ADDENDUM NO. 3

Reference: **New Canada Road (PIN 107036.00)**
City of Lakeland
Shelby County, TN

The following additions, deletions, and/or revisions shall be made part of the Plans dated **August 30, 2024**, for the referenced project. This addendum shall have precedence over the plans and specifications on all items listed and described herein; however, it shall not change the intent and requirement of the plans and specifications for any item not specifically mentioned.

6/20/2025 11:40:50 AM
W:\7008\Transportation_Split\7008 XS_SouthConnectorCanadaRoad.sht

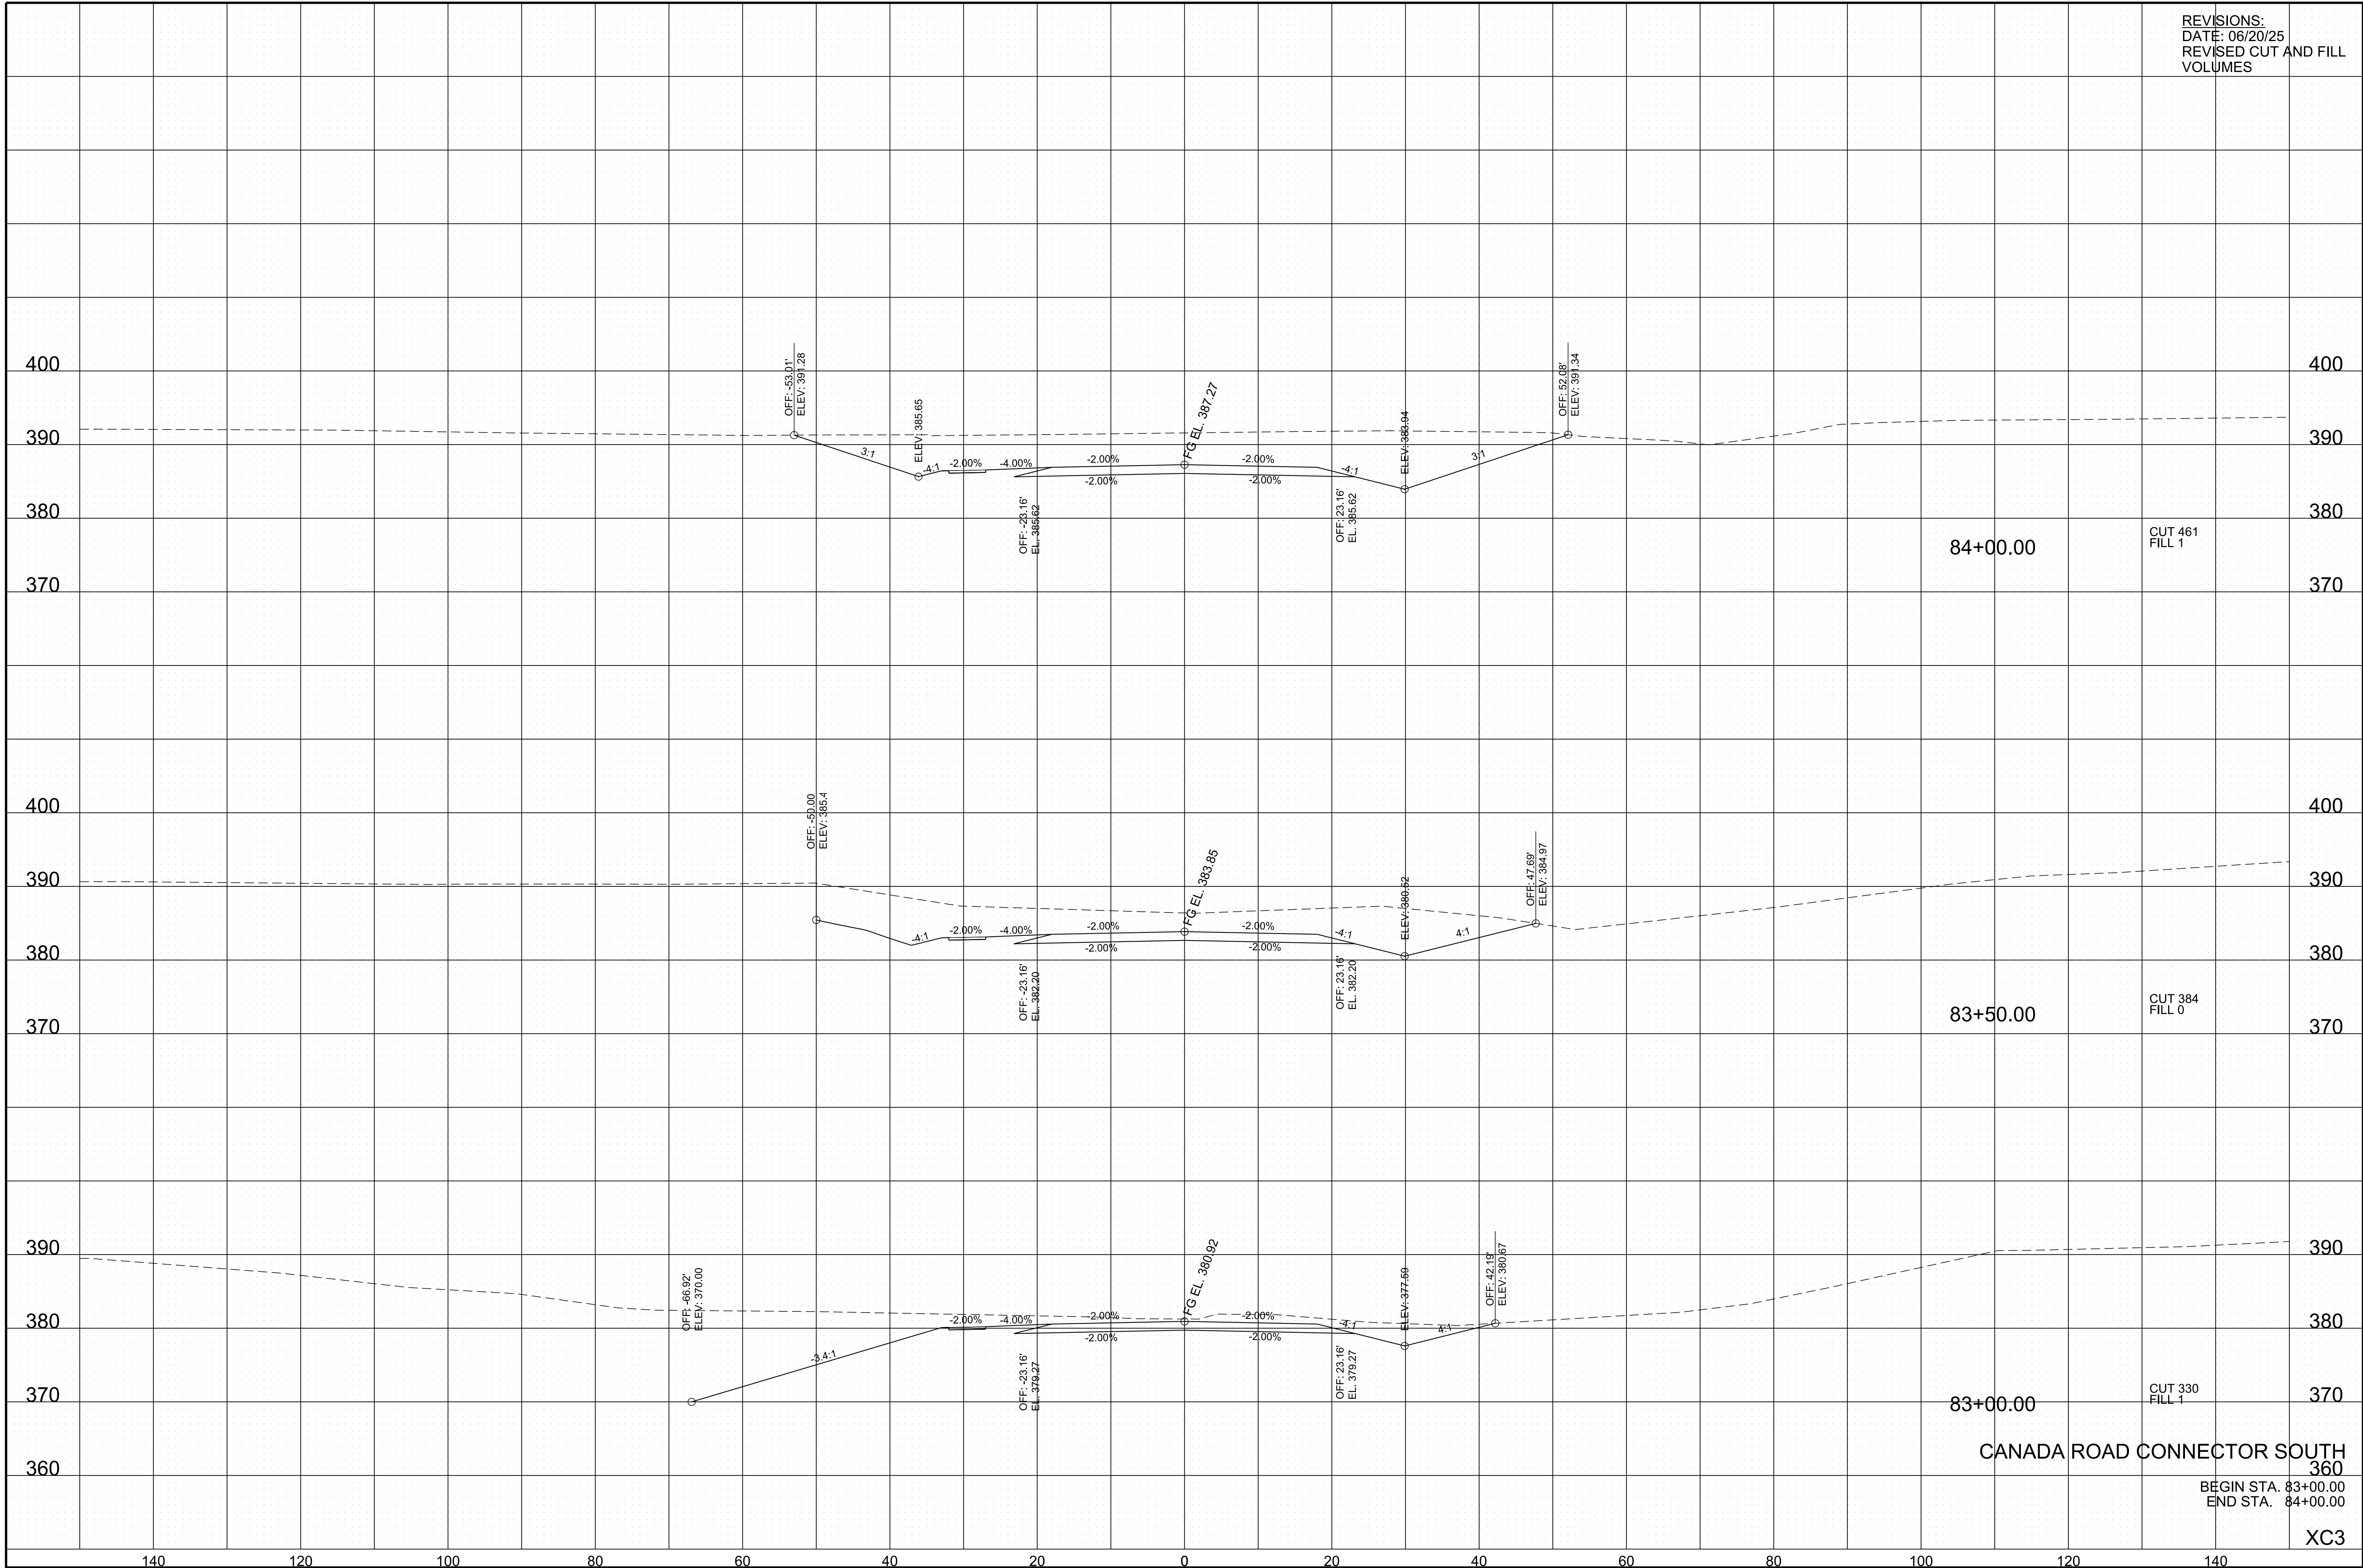
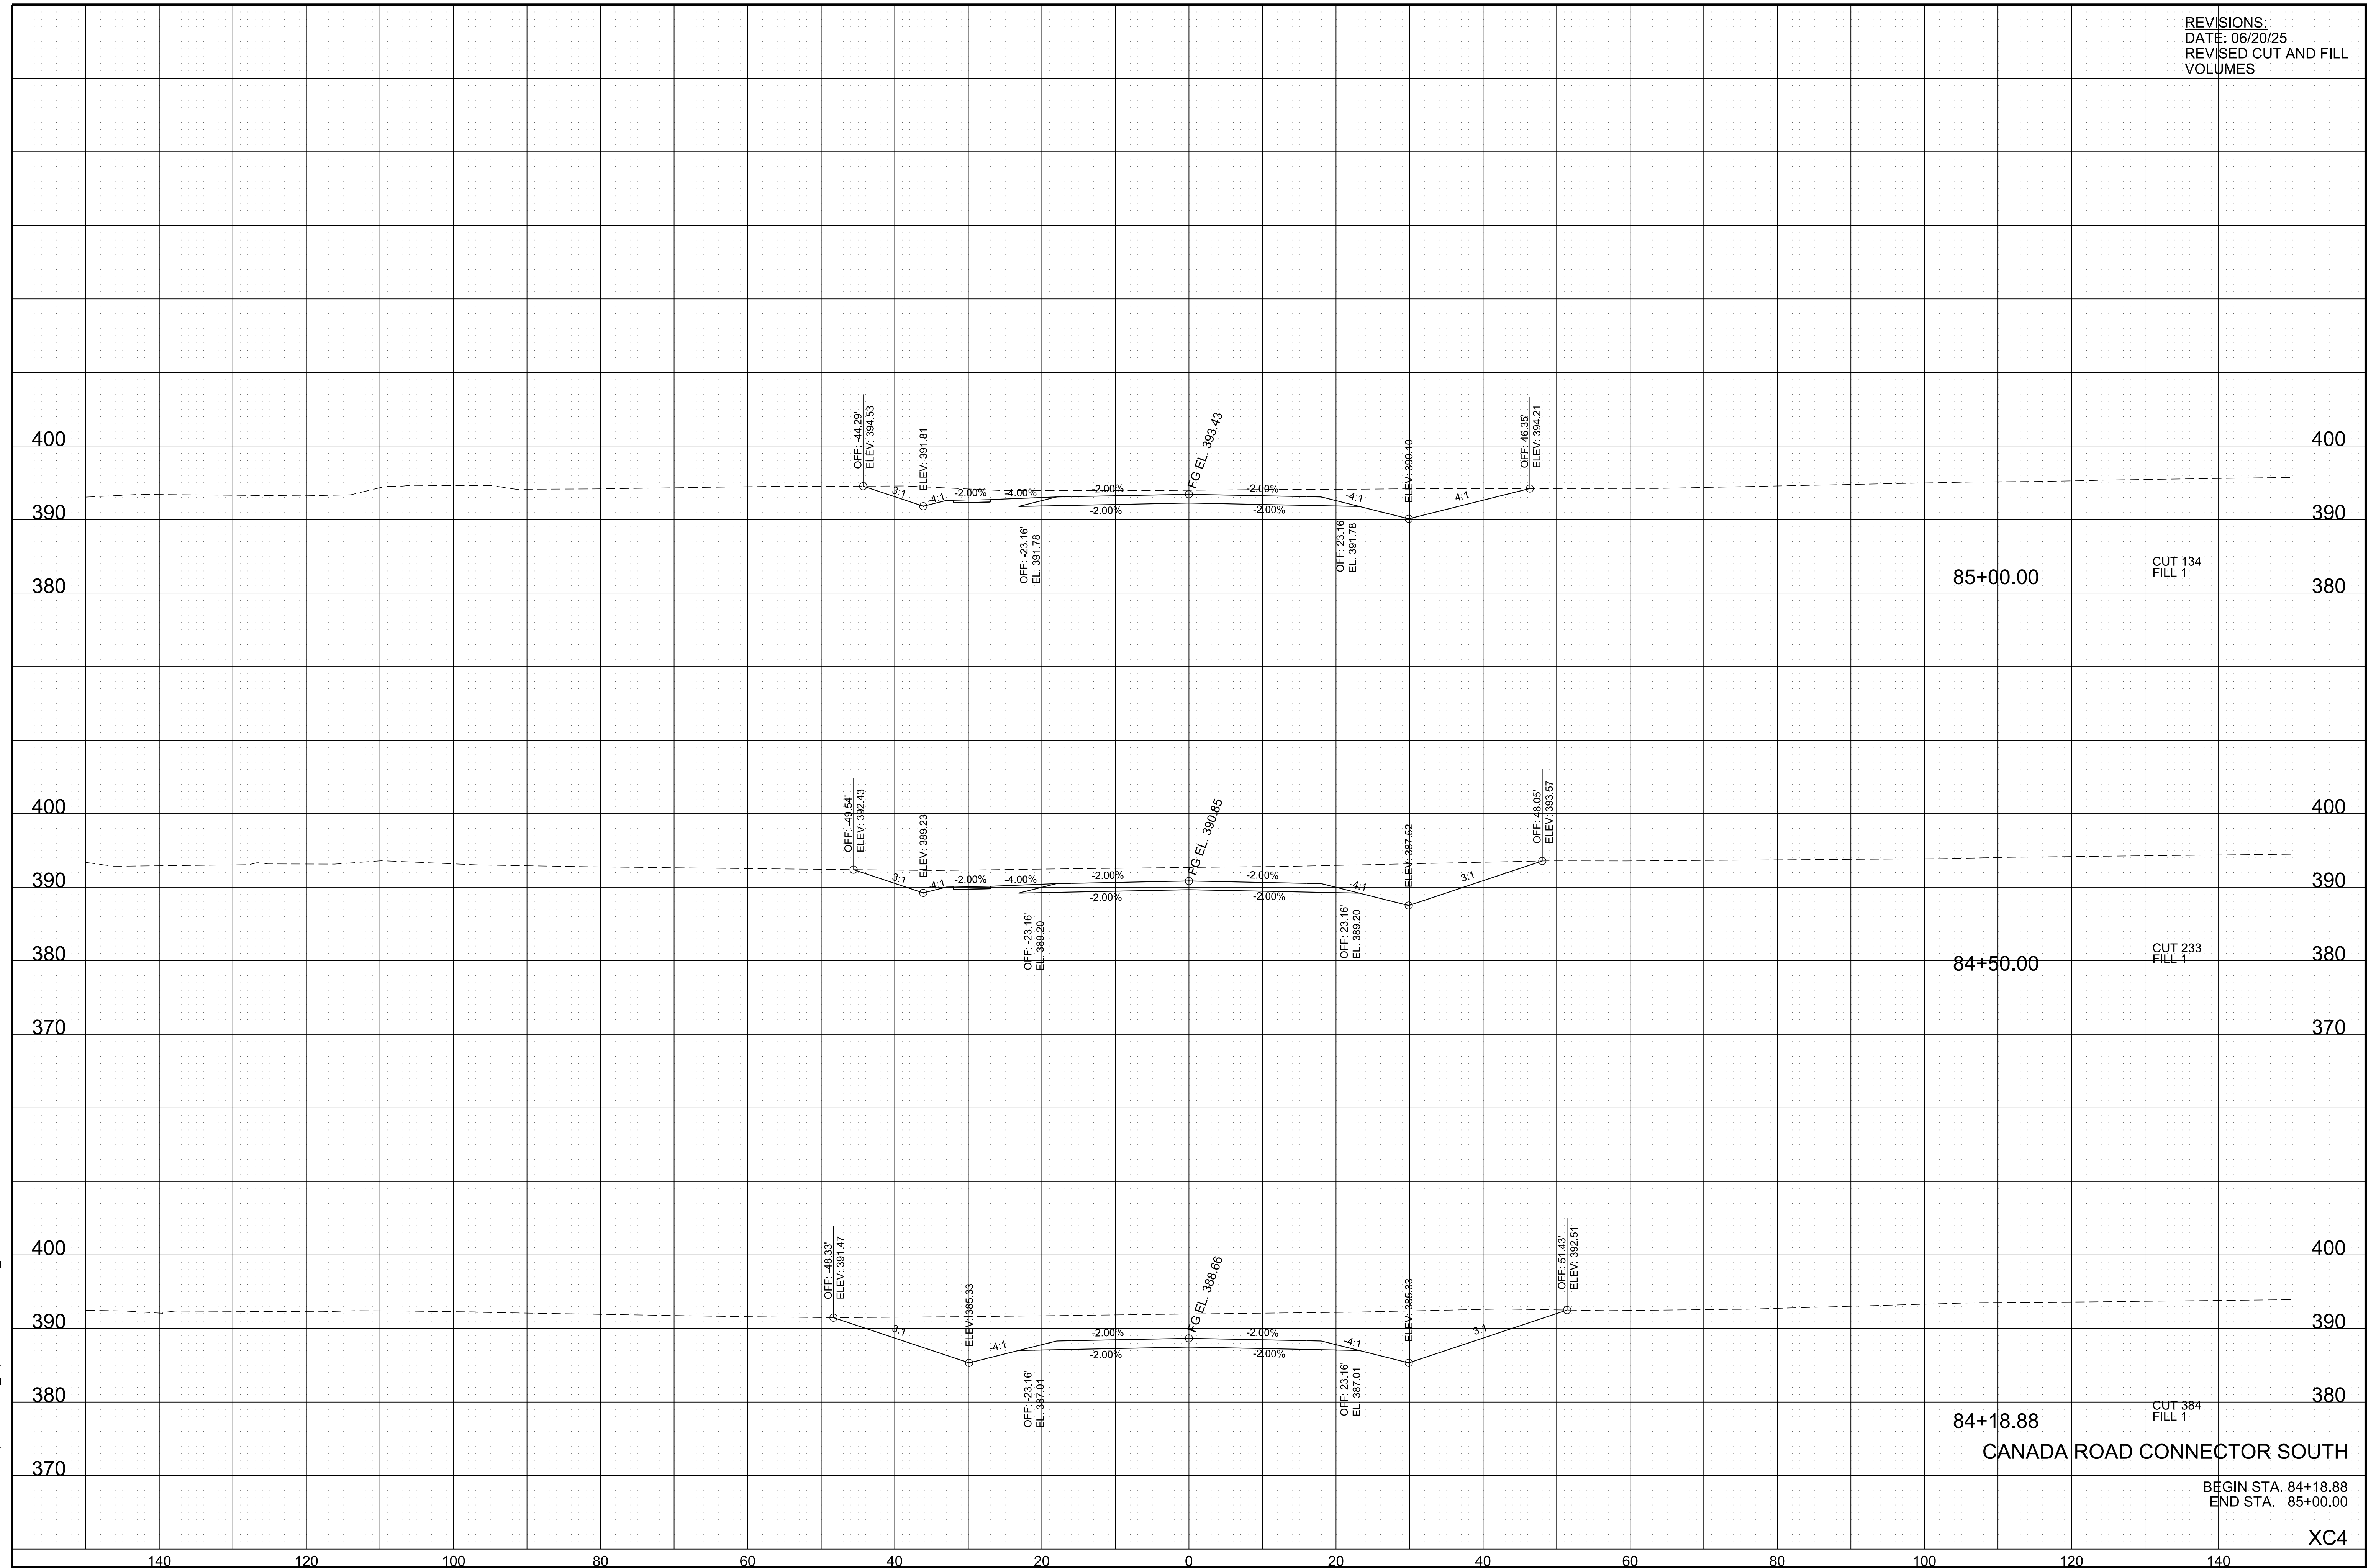
The following plan sheets have been revised and are included with this addendum: 2, 2-1, 2F7 and XC1 – XC5 (Canada Rd. Connector South cross sections).

REVISIONS:	
DATE: 06/20/25	
REVISED CUT AND FILL VOLUMES

REVISIONS:	
DATE: 06/20/25	
REVISED CUT AND FILL VOLUMES

REVISIONS:
DATE: 06/20/25
REVISED CUT AND FILL
VOLUMES
